ADDENDUM NO. 3

PROJECT: Barranca Elementary School Multi-Purpose Room HVAC

Bid# 23-24-117

NOTES:

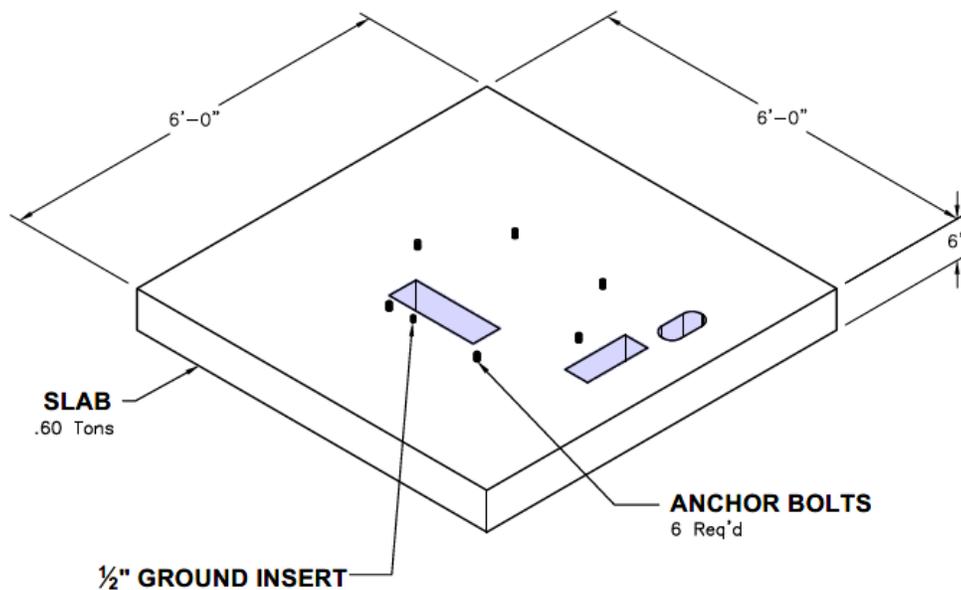
Question: Please confirm that NOTES in sheet M8.1 are NOT part of the project. Notes 2, 3, 4, & 5 state ALL ROOF equipment.

Clarification: Note 2, 3, 4, & 5 is for "Rooftop" units and do not apply to split system (MPR).
